**Archaeological Impact and Mitigation Strategy for the installation of  
Three Crash Decks, Lighthouse Roadway, Skellig Michael, Co. Kerry**  
*Ministerial Consent C0001053, Excavation license no. E005336 & detection license no. R000560*

*Alan R. Hayden  
Archaeological Projects Ltd.,  
July 2022.*

Fig 2. Photograph of location of Crash Deck 1 and plan of proposed foundations Crash Deck 1.

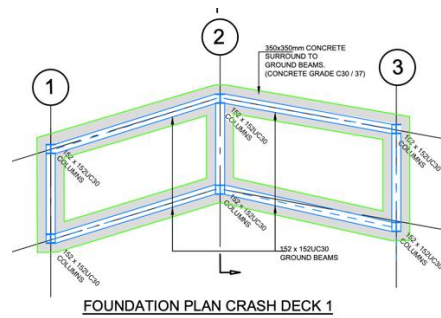
**Crash Deck 1-** (fig. 2). Lower lighthouse roadway, beside men's huts. Not archaeologically excavated and recorded. Fallen material from a recent sweep is obscuring the archaeological features will have to be removed to reveal the underlying archaeological features and the area will have to be planned and recorded archaeologically before construction begins

The foundations for the beam on the inner side of the roadway will be cut through the vertically set stone floor of the lateral drain. Two of the cross beams will cut through the edging on the inner side of the roadway and the third will cut through the concrete wall of the 'pond'. The inner end of the first beam (as marked by a blue painted rebar on site) and the line of the inner beam at the back of the first bay appears to lie too far towards the cliff face and would require removal of a substantial part of the cliff face above modern ground level. This would be unacceptable and so the lines of these beams will have to be altered to avoid this impact

The concrete wall of the 'pond' in the Area of Crash Deck 1 will have to be cut by consaw to facilitate the construction of a cross beam.
